**CITY OF TEMPE
DEVELOPMENT REVIEW COMMISSION**

Meeting Date: 07/24/2018
Agenda Item: 3

ACTION: Request a Zoning Map Amendment from R1-6, GID and MU-4 to PCC-2 and a Planned Area Development Overlay consisting of seven commercial buildings ranging from five to twelve stories on approximately 18 acres; three Use Permits for a hotel, entertainment, and outdoor vending; and a Development Plan Review for Phase One consisting of a six-story 185,759 s.f. biomedical research office and a six-story parking structure for IDEA TEMPE, located at 1000 West Rio Salado Parkway. The applicant is Berry Riddell, LLC.

PLANNED AREA DEVELOPMENT OVERLAY FOR IDEA TEMPE SITE PLAN - OVERALL DEVELOPMENT OPTIONS

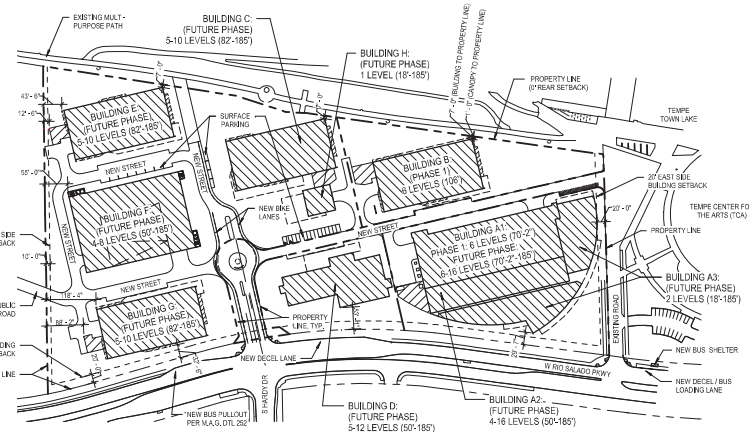
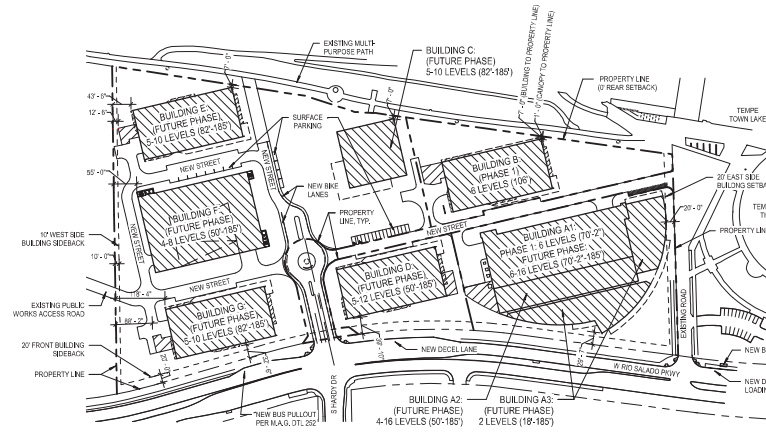
On June 19th, 2018 a resubmittal of the formal application was made. Except for formatting and technical corrections, and a few minor modifications, no significant changes were made to address prior comments. After requesting that Building C be reoriented to provide a clear path of travel for public to the multi-modal path, and preserve the public view of the mountains, the applicant submitted two additional options to address future phases of development and provide flexibility in the entitlement process. Phases one and two, located on lots one and two, would be determined by this request, the future phases three through eight, located on lot four, would be approved based on the site plan Options A, B and C.

- Option A site plan is the applicant's preferred plan, which was submitted with the RFP and the MDA for Council review.
- Option B site plan rotates the floorplate of Building C to allow more permeability of the site.
- Option C site plan provides a smaller building footprint, opening the site for more landscape and open space, and greater protection of the view corridor. Options A and B future building C blocks direct multi-modal path connection to Town Lake Path. Option C has a reduced footprint for building C, however Building D is modified and creates the same visual block through the site, enclosing the campus.

The proposed PAD includes three site plan options, for approval with this request. None of the options address Planning staff comments regarding Building C, future phase 4 as outlined in the site plan review comments earlier in this report. Nor do these site plan options fully address Traffic Engineering staff comments regarding the configuration of the Hardy Drive alignment and required lanes, bike lanes, sidewalks and the multi-modal path connection. The lot configurations were designed to maximize views for the business campus, minimize solar exposure to buildings by orientation for energy efficiency, and provide building footprints large enough to market to a flexible future tenant mix. Option A is the applicant's preferred site plan, as presented in the original RFP response and MDA as a conceptual plan. Through the past year of discussion, this has not significantly changed. Option B provides a rectilinear footprint for the TCA Annex, which had not been discussed prior to the submittal. This plan re-orientes Building C to provide a more direct connection for the multi-modal path connection and preserve a part of the existing view corridor. Staff would support this option without the changes shown to the TCA Annex, and with traffic engineering requirements for the street configuration and multi-modal path addressed. Option C reduces the footprint of Building C, however, Building D has been made larger, blocking the view and the direct path for the multi-modal connection. Staff would support this option for Building C, with revisions to Building D to match the other two options or be shortened on the west end, and with approval from traffic engineering on the street infrastructure. This issue does not impact Phase 1 of the project, and can be re-evaluated in the future with subsequent phases.
